PLAN CHANGE REQUEST

DATE: 08/15/24 PERMIT NO./REF NO: PRCCP20240215

1. PROJECT: PSE - OTC ADDRESS: 325 Todd Road NW

9. APPROVED CIVIL PLAN SHEET NUMBERS AFFECTED: C2.2E, C2.2F, C2.2G

C2.2E

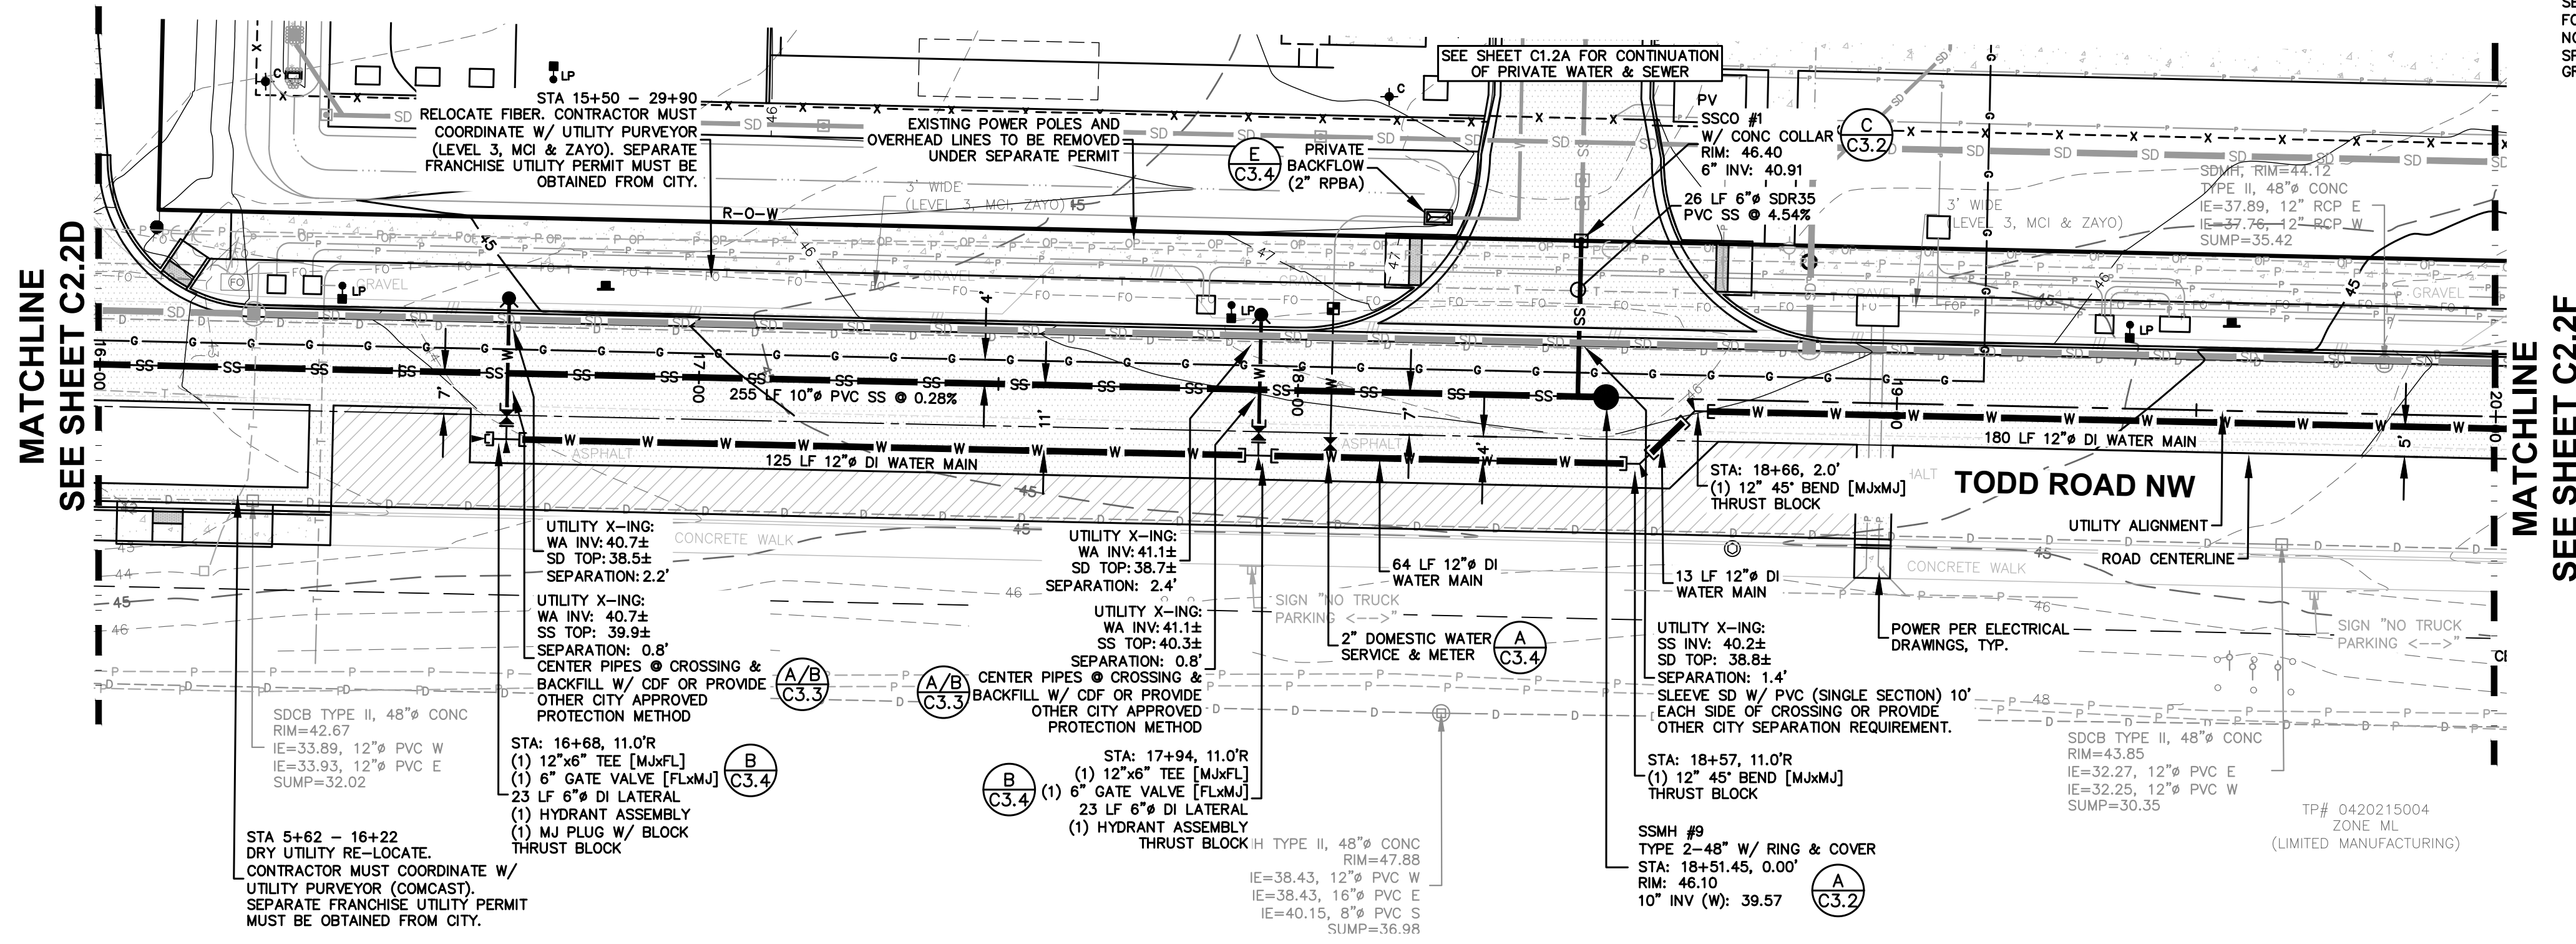
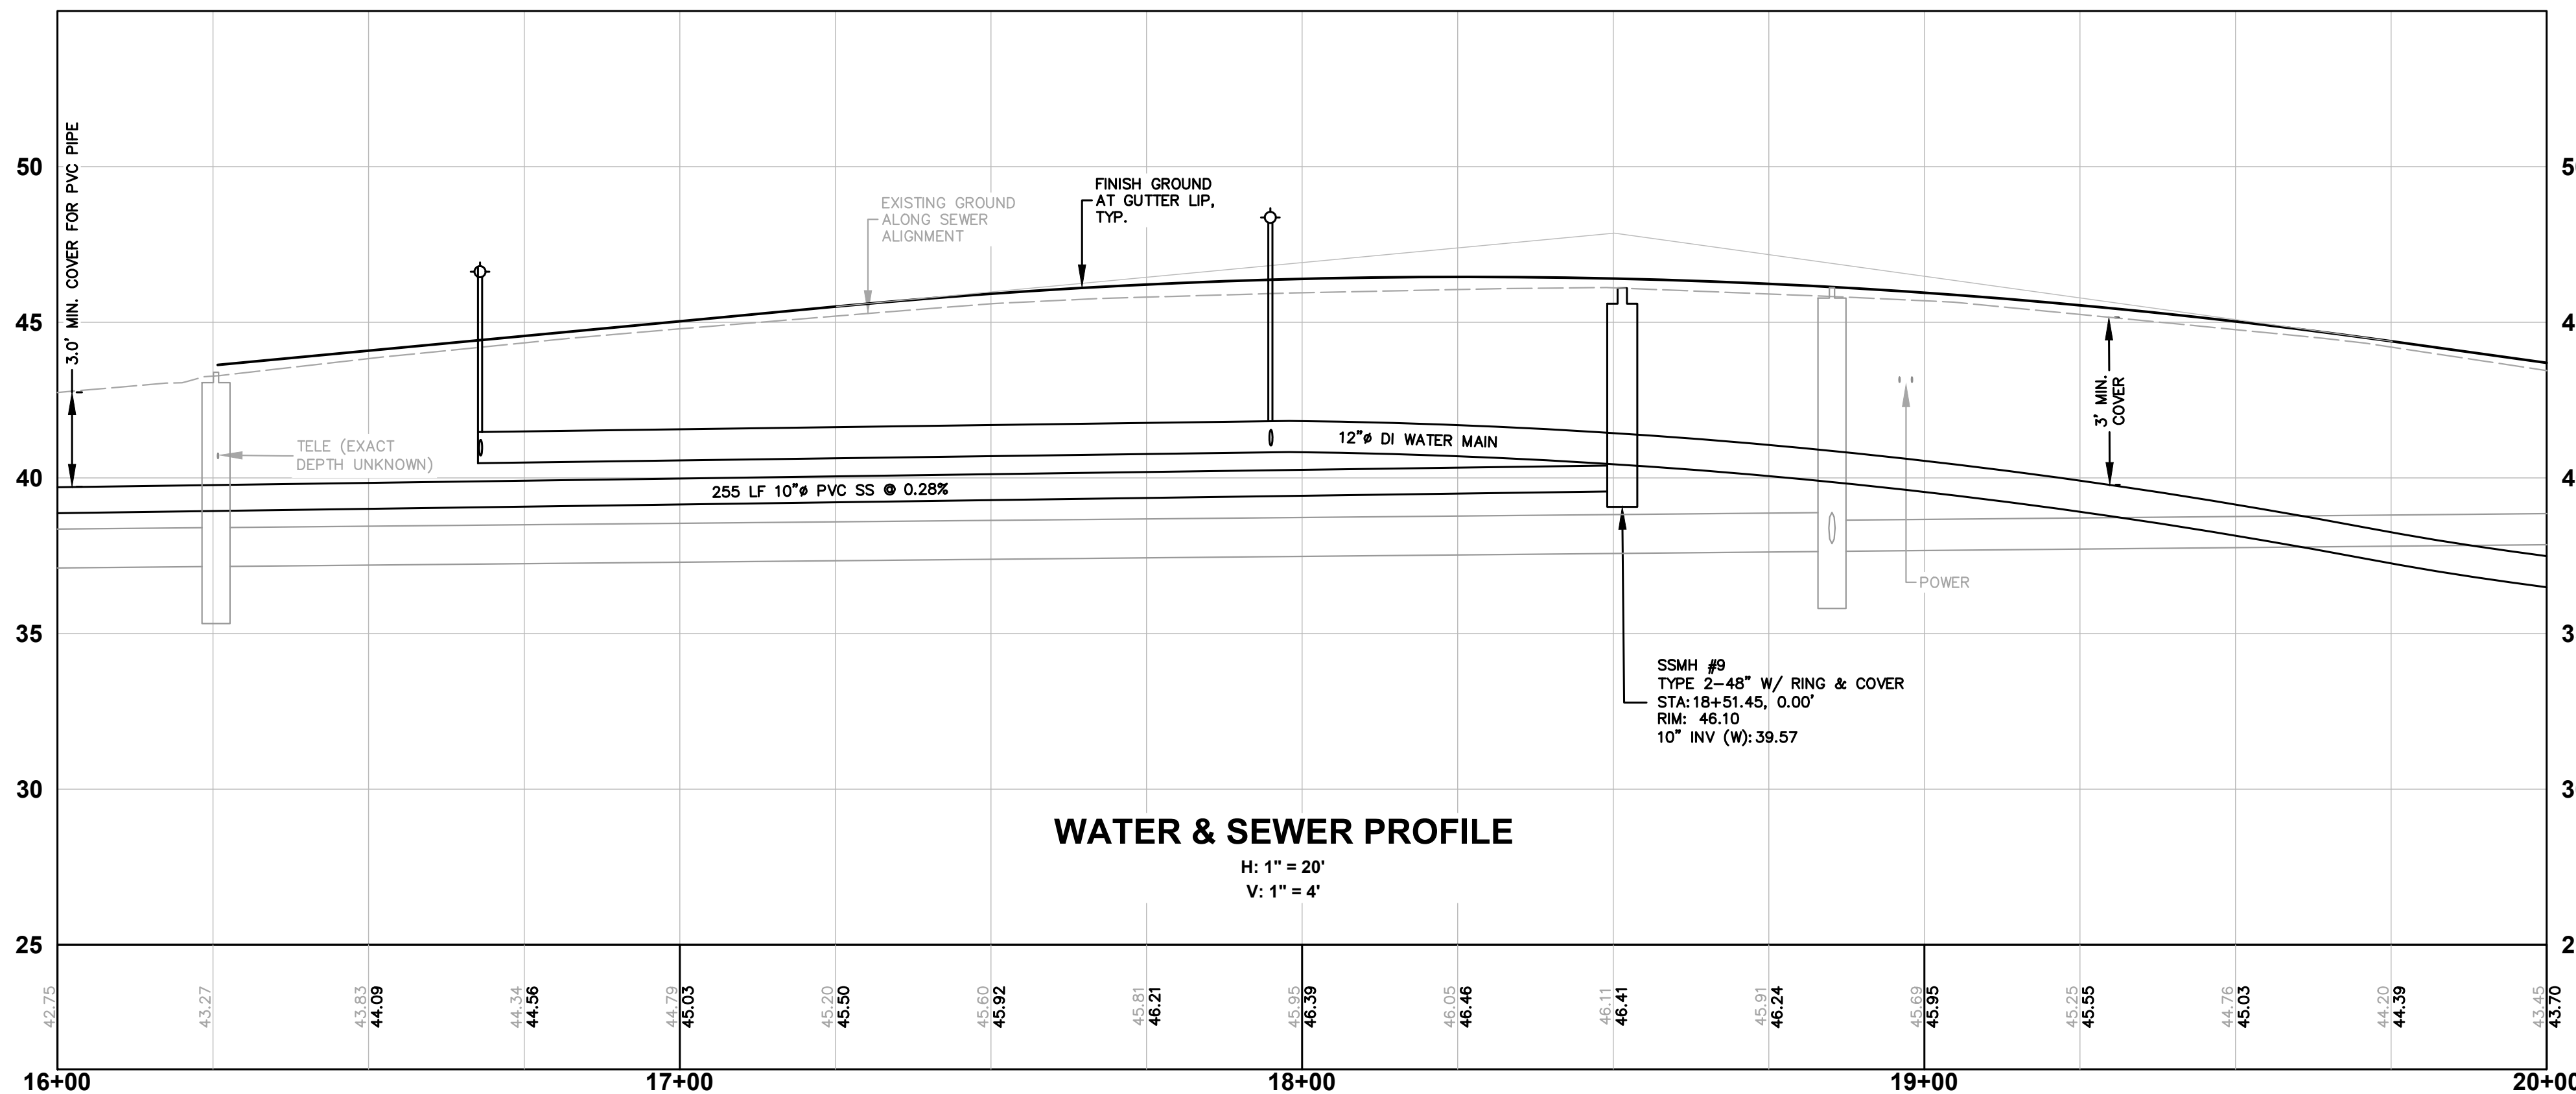
This change will move the water main along Todd Road from the south side to the north side of the road. This will shorten the hydrant laterals and eliminate paving work on the south side of the road.
